AGENDA
CITY OF GLENWOOD SPRINGS
Planning and Zoning Commission
Regular Meeting
MAY 25, 2021
Council Chambers, First Floor
101 W. 8TH STREET
6:00 PM

MINUTES
City of Glenwood Springs
Planning and Zoning Commission
Regular Meeting
August 13, 2020
Zoom
6:00PM

TITLE	OFFSITE DRAINAGE PLAN
DRAWING NO.	C-4.0

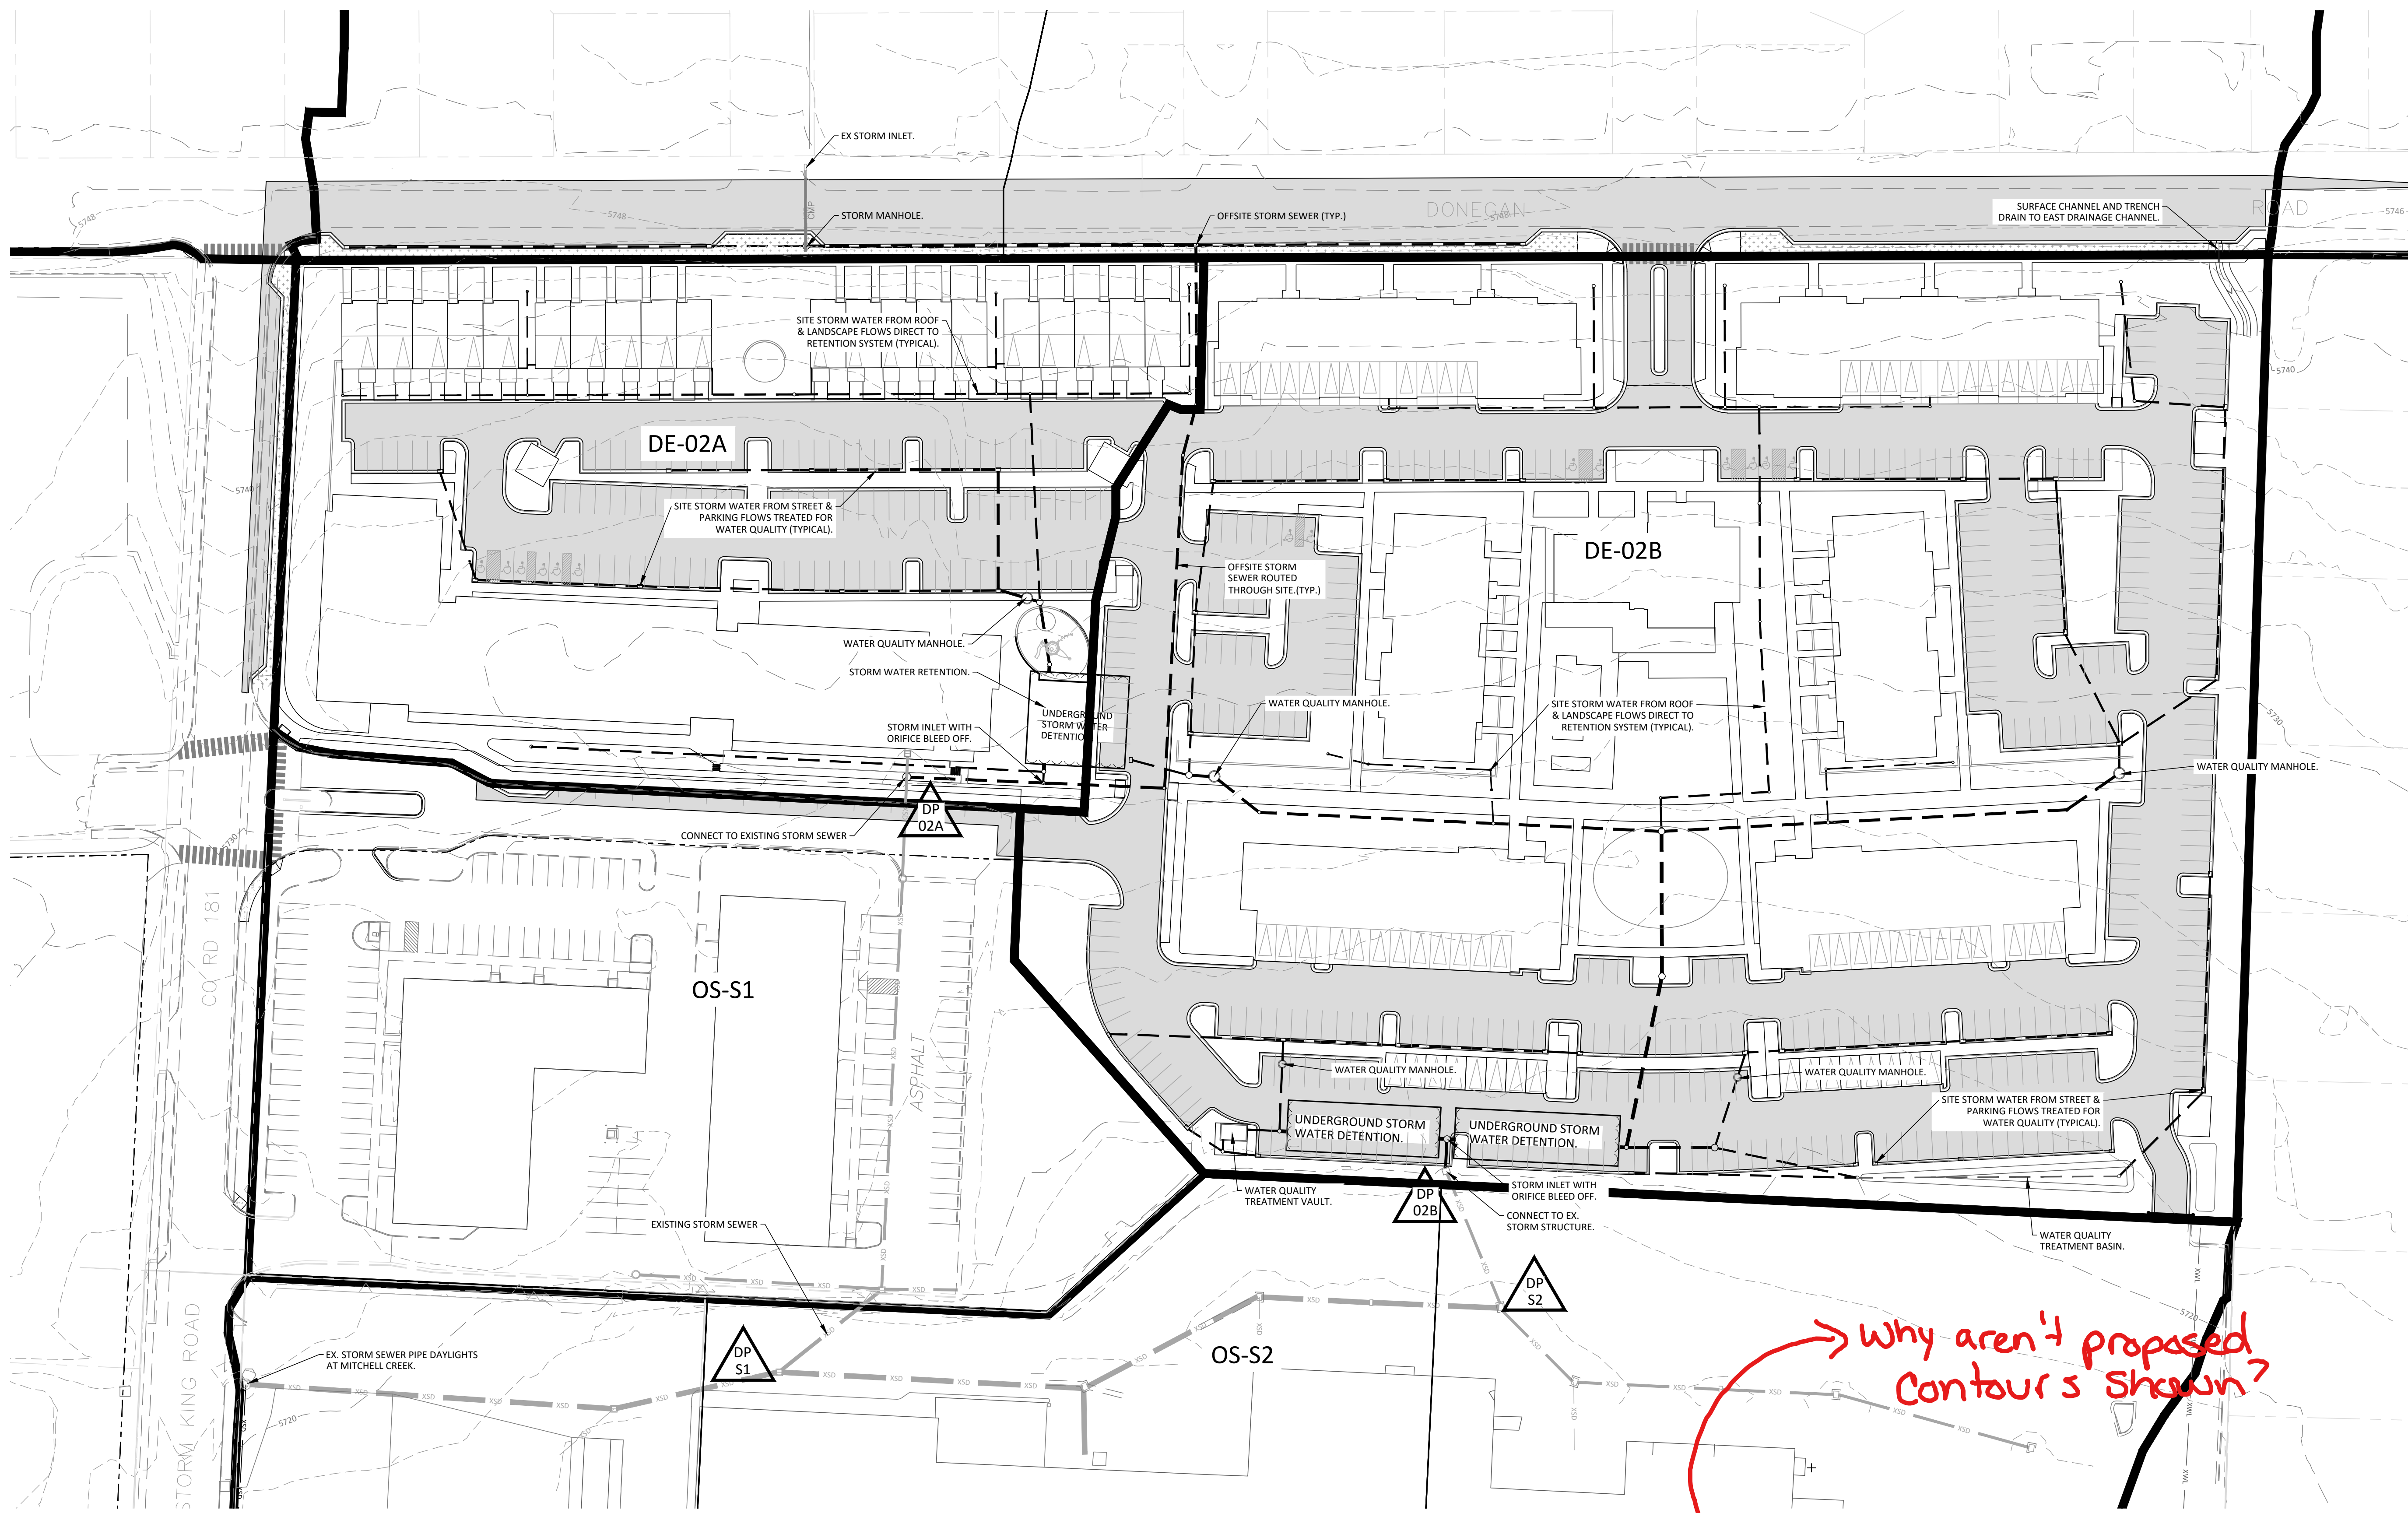
Why aren't proposed
Contours shown?

91		Plan C4.1	1	Show proposed contours	SE	Concept contours were added to plan.
92		Plan A2.0	1	Add Legend	HCM	The Applicant provided a legend for open space framework plan.
93		Plan A2.0	2	What are the red lines	HCM	The Applicant removed extraneous lines from illustrative concept plan.
94		Plan A2.0	3	Show utility lines, coordinate w/ tree plantings	HCM	The Applicant will refine landscape planting location with revised utilities at the time of Major Site/Architectural Plan review.
95	GarCO	1 in part	1	Review with Road & Bridge on impact to County Rds	SE	The applicant met with Wyatt at County Road and Bridge on 03/04. Wyatt reviewed and provided comments on this application to Sheryl.
96			2	Significant added traffic on lower density res. Areas	SE	The traffic is added to existing collector roads which provide direct access to State Highway 6.
97			3	Donegan & Mel Ray not designed for proposed traffic	SE	The traffic study demonstrate good levels of service on the road network surrounding the site.
